ADDENDUM #2

North Carolina Aquariums
Jennette's Pier Decking Repair and Replacement
SCO ID# 22-25352-01A

Addendum #02

5 **FRP Deck Plank at Bath House Deck**

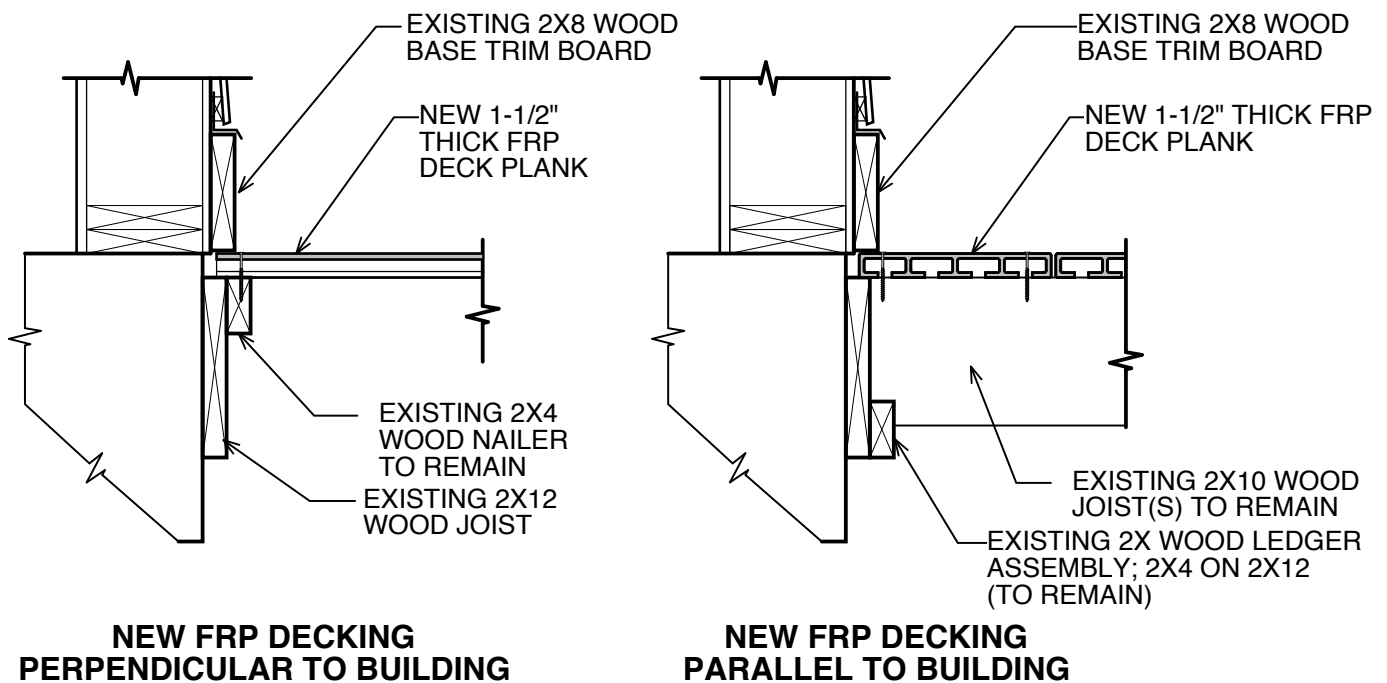
- What type of edge treatment/edge band do you want to see around the perimeter to hide the exposed edge of the FRP decking?

- Do we need to add blocking or double joists at the joints so the screws will have enough material to attach to?

- Do we need to add blocking along the building perimeter to help with screw attachment?

Response: The existing trim that covers the existing decking edges will be replaced as shown on **BULLETIN 001 - ATTACHEMENT #1.**

Response: Maximize lengths to reduce splice locations. Blocking will be added at decking splice locations across floor framing. See **BULLETIN 002 - ATTACHEMENT #2** for blocking placement and screw spacing.

Response: There are currently (2) 2x's at the building perimeter edge of the bath house. Provide more blocking if needed.
BULLETIN 002 - ATTACHEMENT #2

ATTACHMENT #3

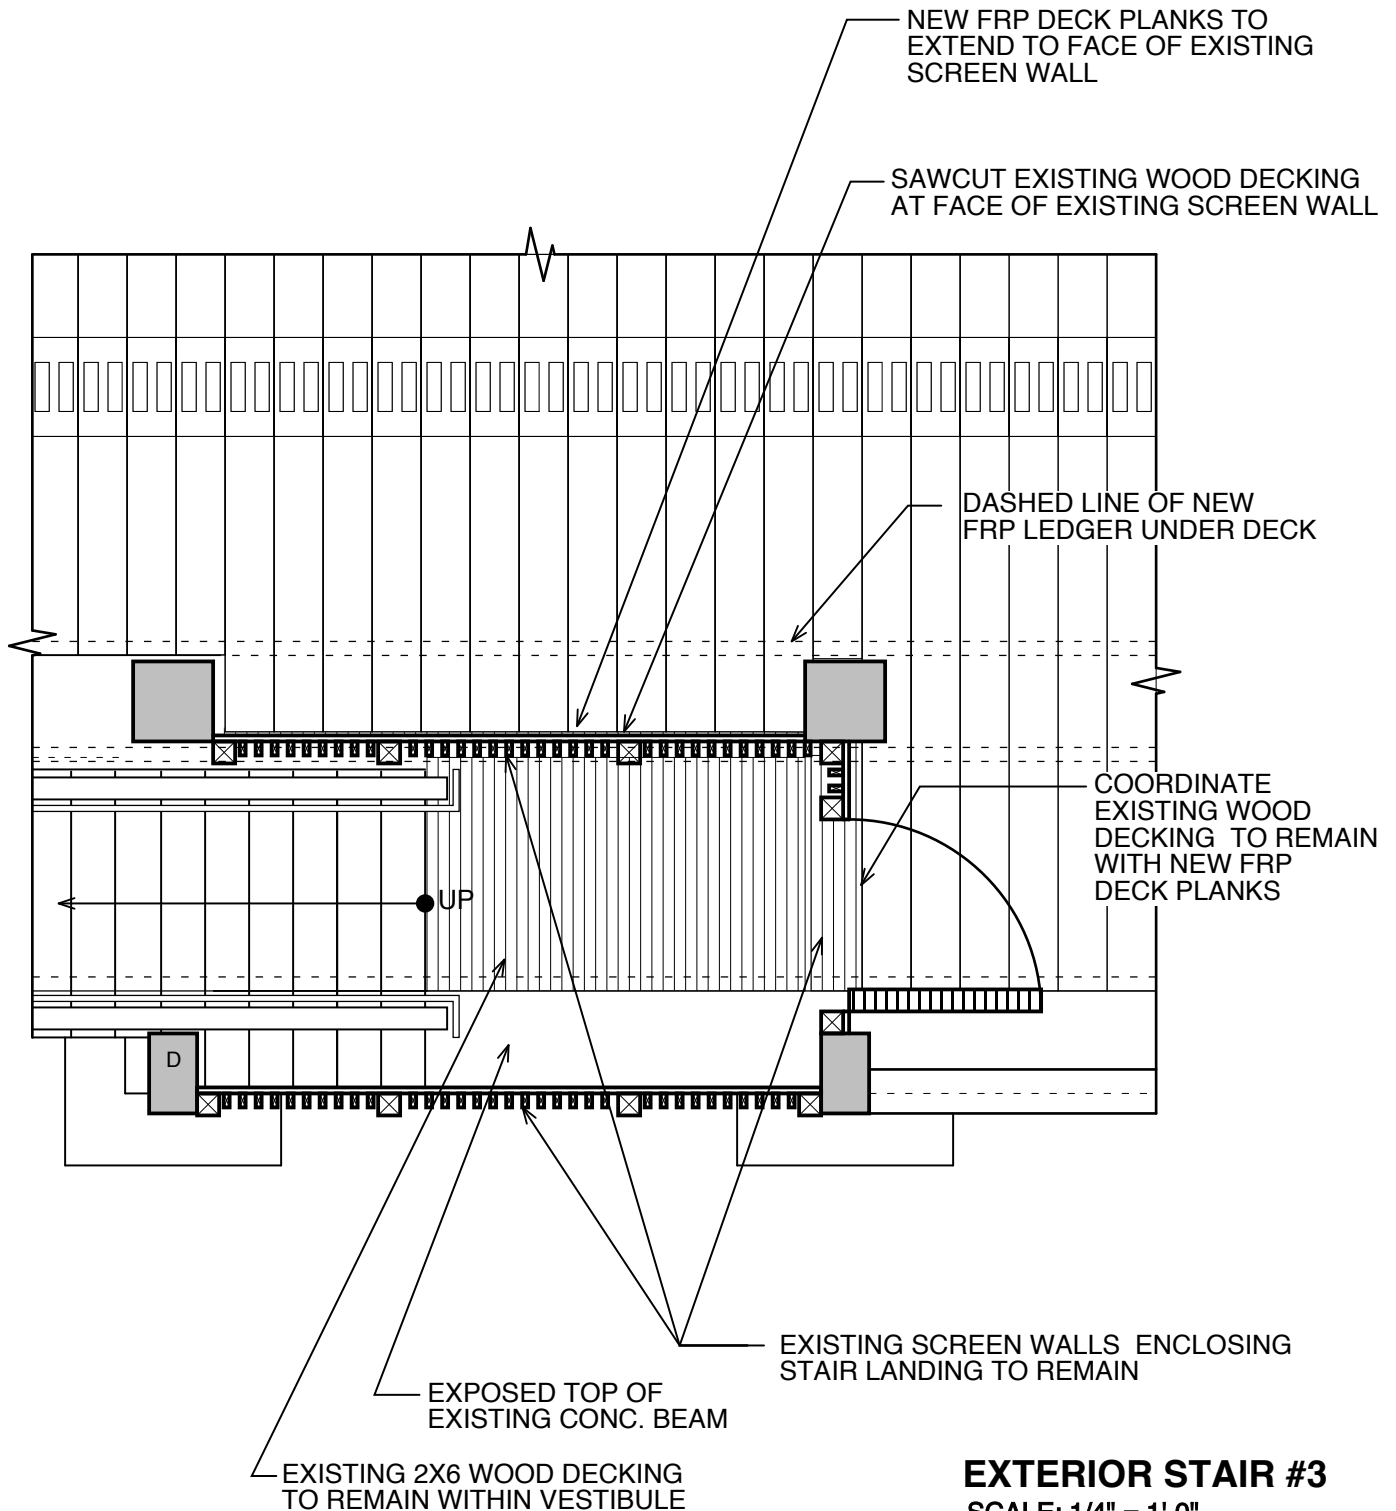
- What do we do with the various gates, hollow metal door, lattice, etc. that are constructed on top of the existing decking. Do we remove and reinstall these items, are they to be reinstalled with new material to match existing.

Response: See **BULLETIN 003 - ATTACHEMENT #3** for details at the southern stair area showing where the existing decking stays and the new decking is installed.

ATTACHMENT #4

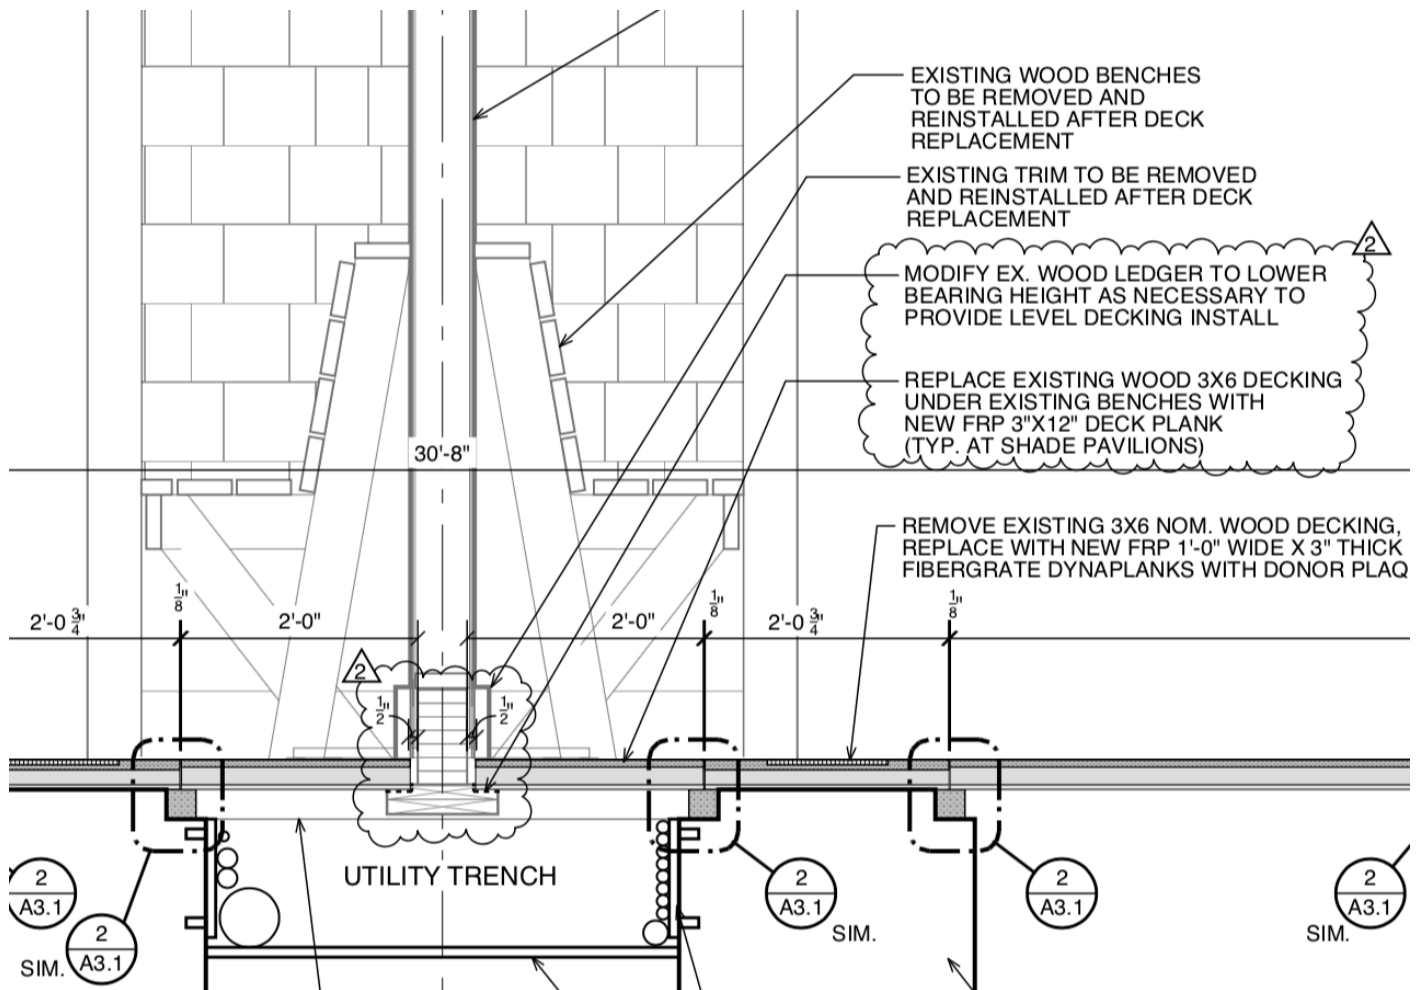
- How do we attach the decking or remove the existing decking in areas where walls are on top of decking (obviously the wall cannot be moved) such as at the pavilions and along the main pier house extend out over the existing decking.

Response: See **BULLETIN 004 - ATTACHEMENT #4** that replaces the illustrated portion of detail 1/A3.1 for decking bearing connection at the two pavilions out on the pier. There are existing bearing connections at the pump house that is on the ocean end of pier.
